**Report Of The May 5, 2010 CSCC Meeting:
Arbor Grove PUD – Geimer Greenhouse Property**

MEMORANDUM

TO: CSCC CHAIR SMITH AND COMMITTEE MEMBERS
FROM: JAMES M. HOGUE, VILLAGE PLANNER
DATE: April 29, 2010
RE: May 5, 2010 MEETING ISSUE REVIEW

**Preliminary
 SITE PLAN
 Arbor Grove
 VILLAGE OF LONG GROVE, ILLINOIS**

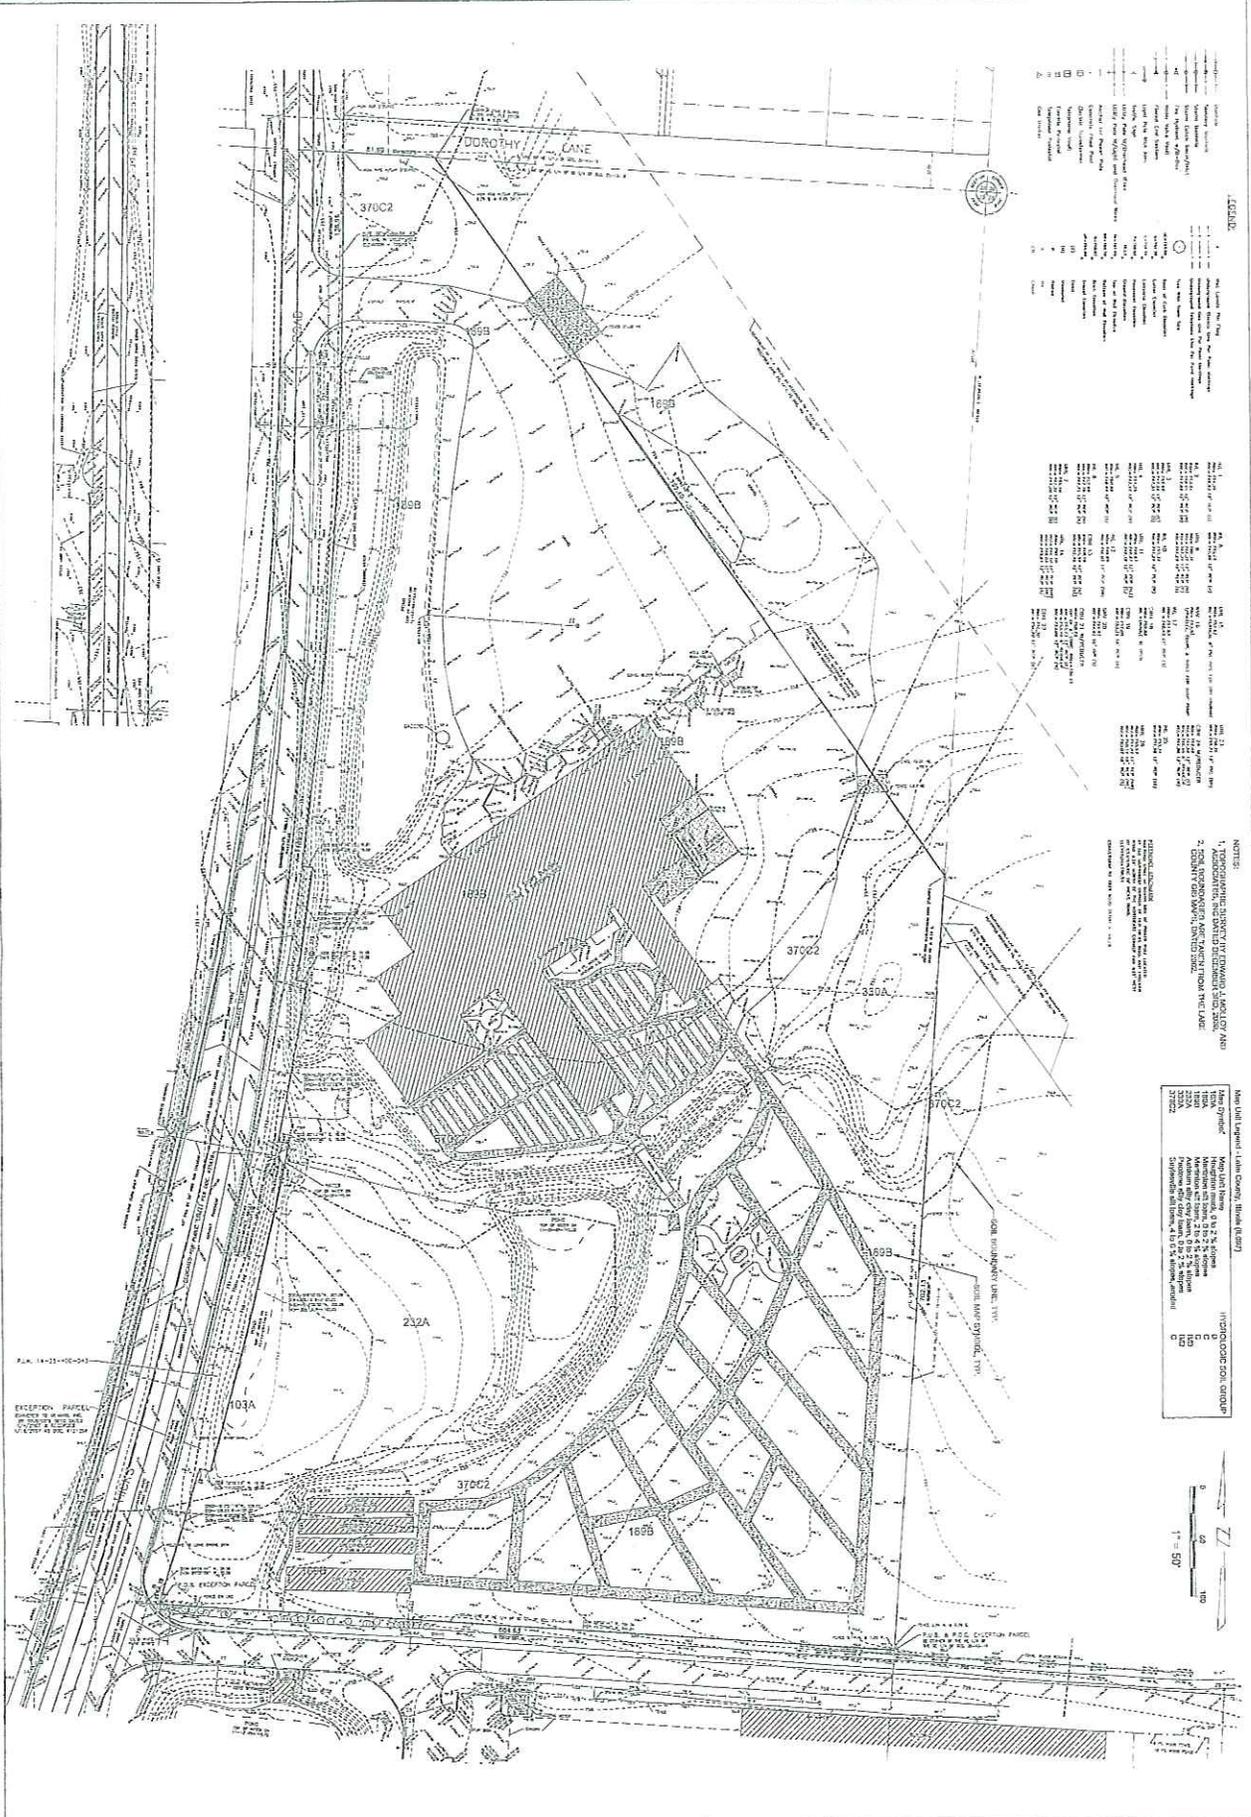
The property in question contains no flood hazard area but does contain wetlands and lowland conservancy soils (see Sheet 7 of 7 from Cross Engineering attached). While most of the wetland/lowland conservancy soils will remain undisturbed and enhanced, a small area, approximately 9,250 sq. ft. in area is proposed to be filled. Such excavation/filling may be permitted as a special use per the Village Code (excerpt as follows);

There is one area of lowland conservancy soils identified on the property one of which will be disturbed by the development (See attached – highlighted in green). The area would be filled to accommodate a small portion of total parking area on-site. As the bulk of the wetland/lowland conservancy soils will remain protected and enhanced by the proposal, and the area of disturbance is on the edge of the conservancy soils, staff suggests that the request be considered more as an adjustment to the boundaries of the lowland area rather than a wholesale elimination of a large area of lowland conservancy soils.

The CSCC should also review and comment on the proposal in general with regard to the work in the lowland conservancy/wetland areas, as well as improvements (pathways, plantings, detention and bermed areas) located within the scenic corridor. The following excerpts from the Village Code with regard to scenic corridors are included for CSCC consideration in their review;

The petitioner is requesting that the scenic corridor be reduced from the required 100' to minimum of 60' feet. This standard may be varied as part of the PUD/Subdivision process.
